ZON2006-00121

Hubbell Realty Company (Developer) - Vicinity of 31st Street and Carpenter Avenue

Communication from the City Plan and Zoning Commission advising that at their meeting held October 5, 2006, the following action was taken:

**PRELIMINARY CONCEPTUAL PLAN FOR DRAKE-HUBBELL HOUSING**  
 A PLANNED UNIT DEVELOPMENT IN THE CITY OF DES MOINES, COUNTY OF POLK, STATE OF IOWA  
 SHEET 1 OF 4

PRELIMINARY CONCEPTUAL PLAN FOR DRAKE-HUBBELL HOUSING  
A PLANNED UNIT DEVELOPMENT IN THE CITY OF DES MOINES, COUNTY OF POLK, STATE OF IOWA  
SHEET 2.1 OF 4

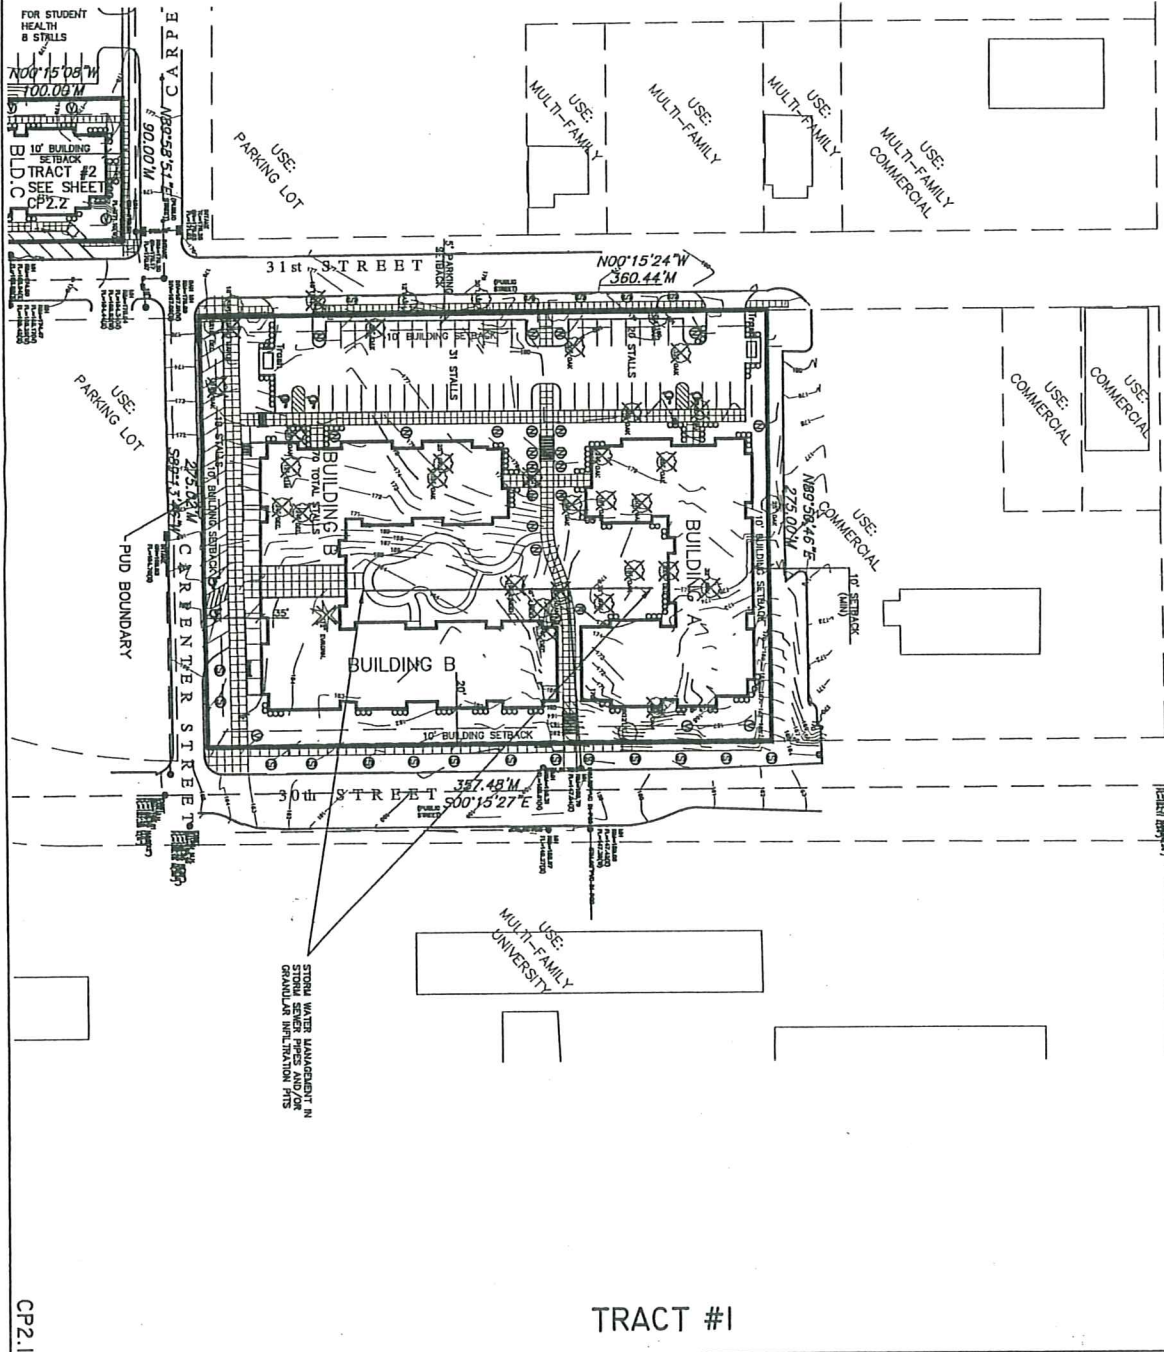
In reviewing the plan, staff believes there is some potential to save a few of the large Oaks in the western parking lot on the north block. Staff also believes that a tree for tree replacement of new plantings to mature tree removed should be required within the overall site and that notes should be added to the plan to ensure protection of trees to be saved during the demolition, site preparation and construction.

Traffic staff did recommend that the alignment of the sidewalk along the north side of Carpenter Street should be adjusted to direct pedestrians as close as possible to the 30<sup>th</sup> Street crossing and the alignment of the sidewalk connection on the east side.

Tim Urban: Asked about tree retention in the staff recommendations; asked which trees are identified to retain. Suggested some minor modifications of the orientation of the buildings or placement of the parking lots may allow preservation of some of the large over-story trees.

1. Provision of a note requiring mitigation for removal of any mature over-story trees on a tree for tree (quantity) basis, with the following tree protection language added to the plan for mature trees that are identified to remain:

3. Revise the alignment of the sidewalk along the north side of Carpenter Street to direct pedestrians as close as possible to the 30<sup>th</sup> Street crossing.

Sheet Title  
 Schematic Exterior Elevations

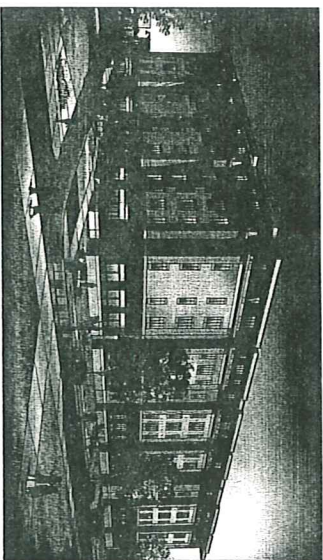
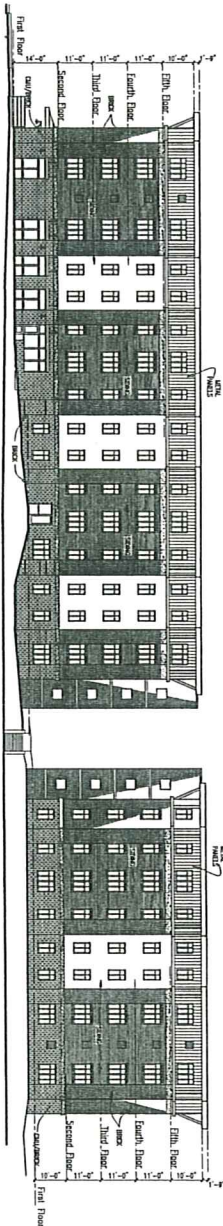
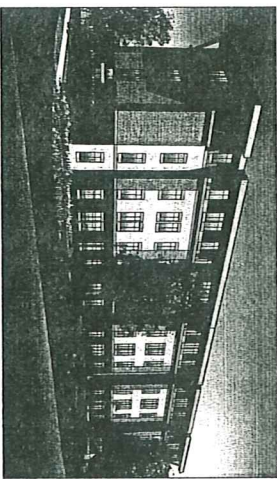
Staff does not believe that the maximum height limitation of 70' is necessary based on the conceptual elevations of the buildings. A 60' height maximum should be sufficient. Notes should be provided requiring the screening of all rooftop mechanical equipment from view on adjacent streets.

5. Revise the maximum height from 70' to 60'.
  6. Addition of a requirement that all rooftop mechanical equipment shall be screened from view on adjacent streets.
